Development Permit Panel

2. Development Permit DP 13-630087

PROPERTY LOCATION: 8680 and 8700 Alexandra Road

2. DP 13-630087 - FOUR (4) SINGLE-STOREY COMMERCIAL BUILDINGS

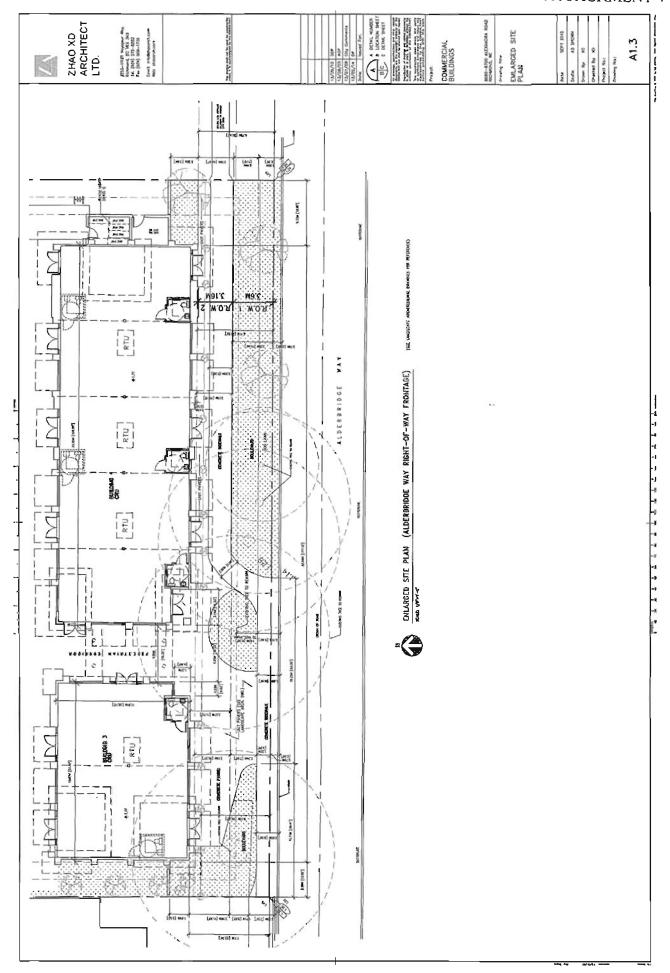
- no real strategy for containing the roof top units; consider a larger enclosure grouping the individual roof top units as opposed to 15 separate enclosures; and
- the proposed development lacks a consistent signage strategy, particularly along Alderbridge; given the incremental and varied building massing and articulation, a sign strategy for the site is needed.

As mentioned earlier, numbers and locations of roof top units are designed in consideration of possible number of future tenant units and architectural composition. The roof top units are taken as beneficial architectural compositional elements rather than leftovers. The roof top units with architectural finish enclosures are designed as an extra visual layer for elevation composition, which add more complexities and richness for building exterior.
